SUBJECT: CERTIFICATION OF THE MINUTES OF THE MEETING OF THE SUBCOMMITTEE ON PLANT OPERATIONS AND FIRE PROTECTION ON JULY 12, 2011

ADVISORY COMMITTEE ON REACTOR SAFEGUARDS
MINUTES OF THE PLANT OPERATIONS AND FIRE PROTECTION
SUBCOMMITTEE MEETING, JULY 12, 2011

The purpose of the meeting was to review and discuss the status of construction, inspection, and licensing activities related to Watts Bar Nuclear Plant Unit 2 (WBN 2). The meeting transcripts are attached and contain an accurate description of each matter discussed during the meeting. The presentation slides used during the meeting are attached to these transcripts. Following are the significant issues and topics discussed in the meeting.

Segmentation of Digital Control System

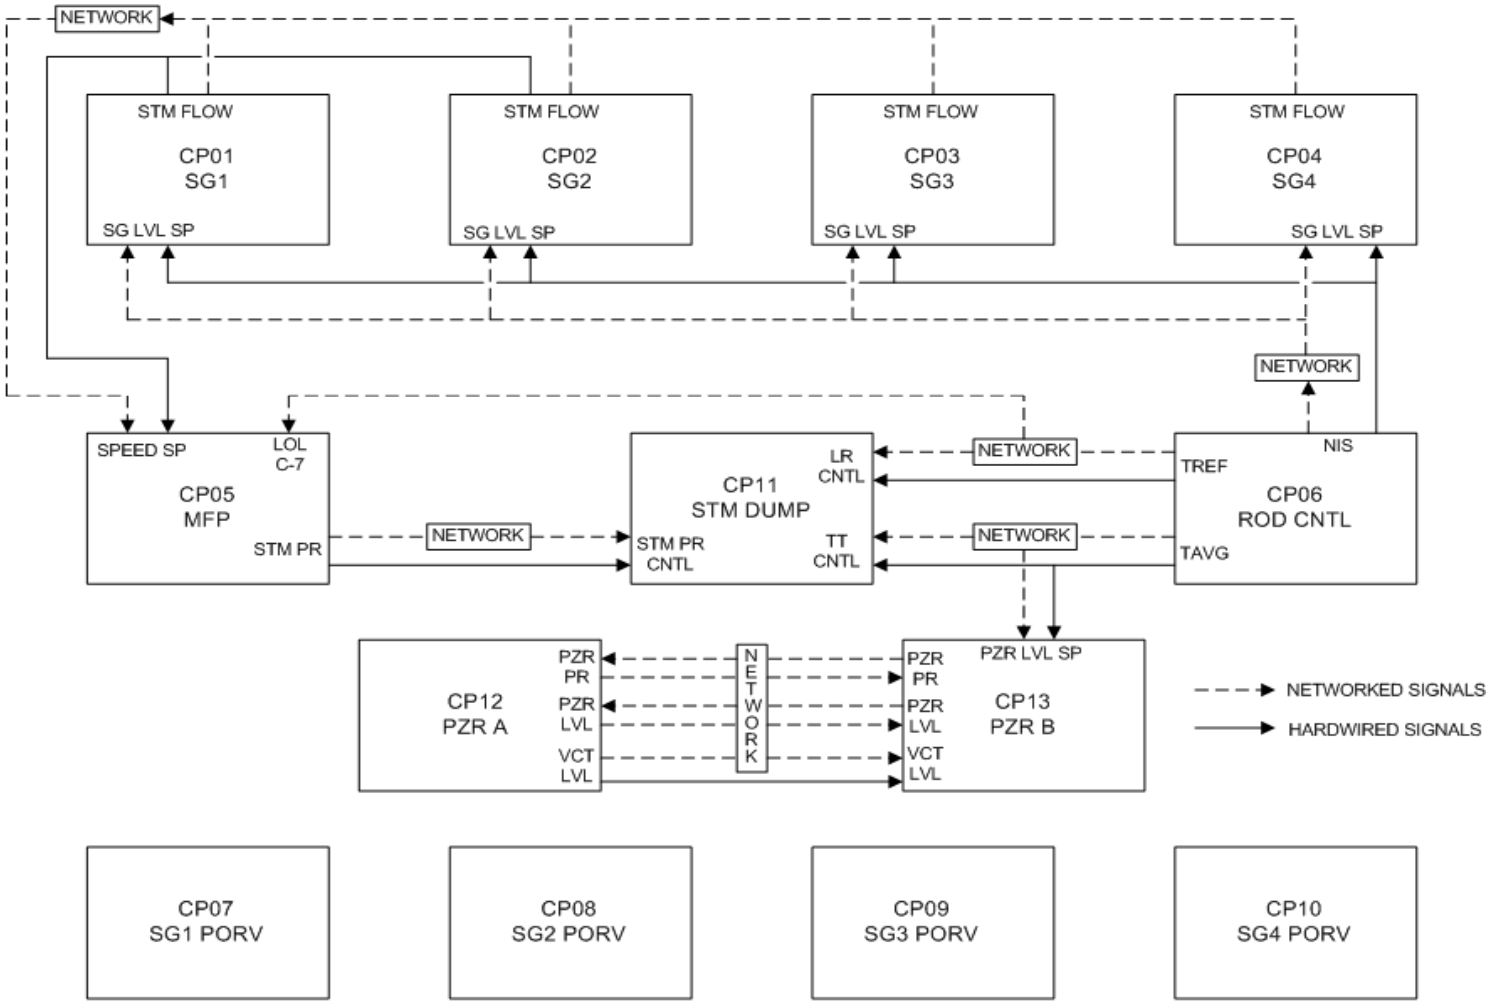
1 MEMBER BROWN: There is one network, and
2 all the processors feed into that one network.
3 MR. HILMES: That's correct.
4 MEMBER BROWN: And it's distributed to all
5 these other points based on addressing, et cetera, and
6 all that other kind of stuff.
7 MR. HILMES: Yes.
8 MEMBER SIEBER: And these are just
9 examples, the networks?
10 MR. HILMES: Yes. I was going to mention
11 that.
12 MEMBER BROWN: Well, there was a comment
13 somewhere, and I'm trying to remember that you went
14 away from a ring bus to some other type of --
15 MR. HILMES: That's on the process
16 computer.
17 MEMBER BROWN: Oh, okay. Not on this
18 thing.
19 MR. HILMES: Right. In reality, there are
20 two --
21 MEMBER BROWN: It's shown in the FSAR.
22 MR. HILMES: There is a paragraph
23 discussing it, but there is no details to that level.
24 MEMBER BROWN: No figures, no discussions
25 of how this operates, or why it's supposed to be good

Process Computer

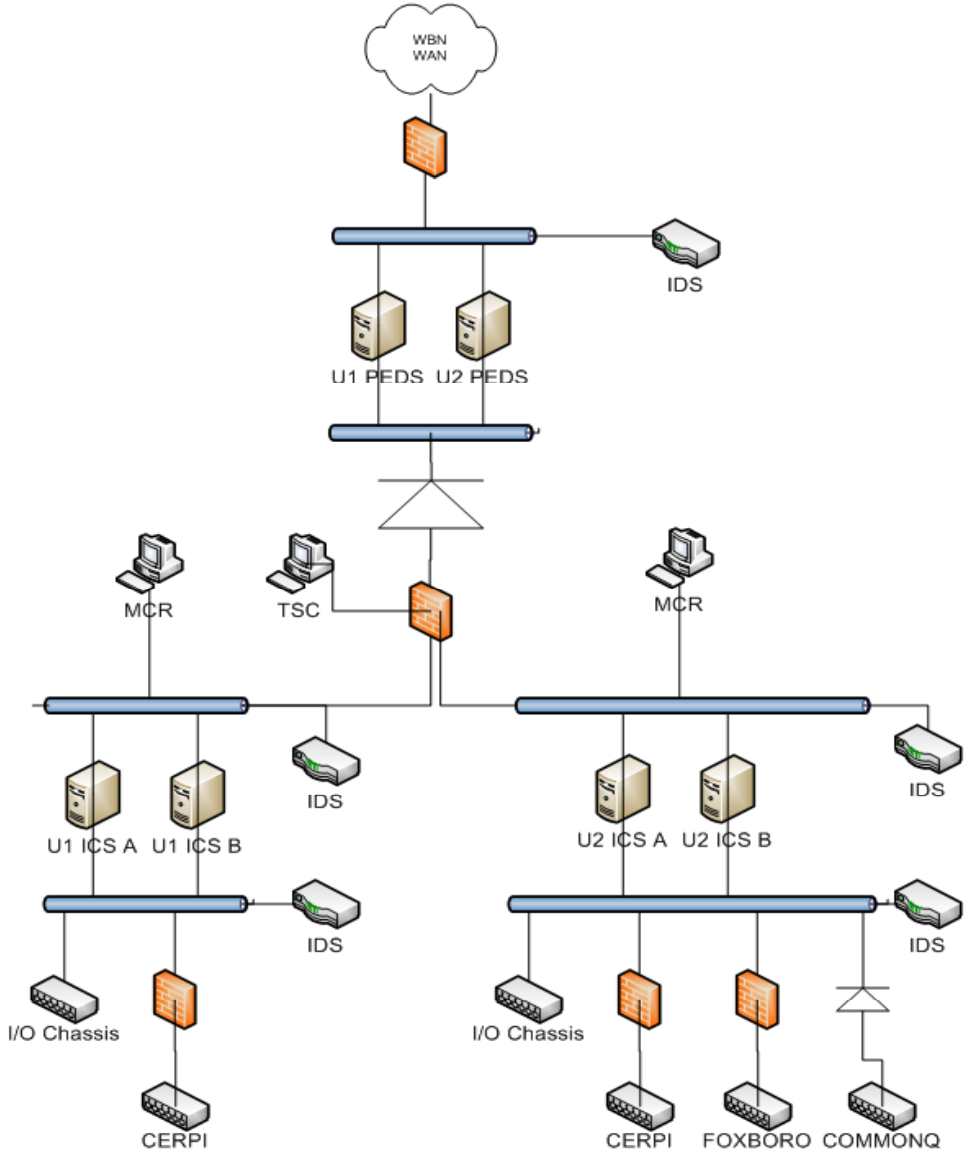
1 What is the nature -- I didn't -- there was -- I could
2 not find any description of the nature of this data
3 diode. Is it a -- and my question goes into the form
4 of, that there's two questions.
5 How isolated is it from this, whatever
6 this PEDS corporate Watts Bar network is? Is it
7 microprocessor-based, software-controlled?
8 MR. HILMES: It is.
9 MEMBER BROWN: So it can be -- so it's
10 told to be one way based on software commands within
11 it, as opposed to a hardwired cyber-protected one-way
12 data transmission path?
13 MR. HILMES: It's a cyber-protected one-
14 way transmission path.
15 MEMBER BROWN: Well, that's --
16 MR. HILMES: But it actually is two
17 computers, okay? And between the computers, there is
18 only a transmit line to the other computer. So it
19 strictly streams data from one computer to the other.
20 MEMBER BROWN: The diode is two computers?
21 MR. HILMES: Yes.
22 MEMBER BROWN: And you're -- I'm not
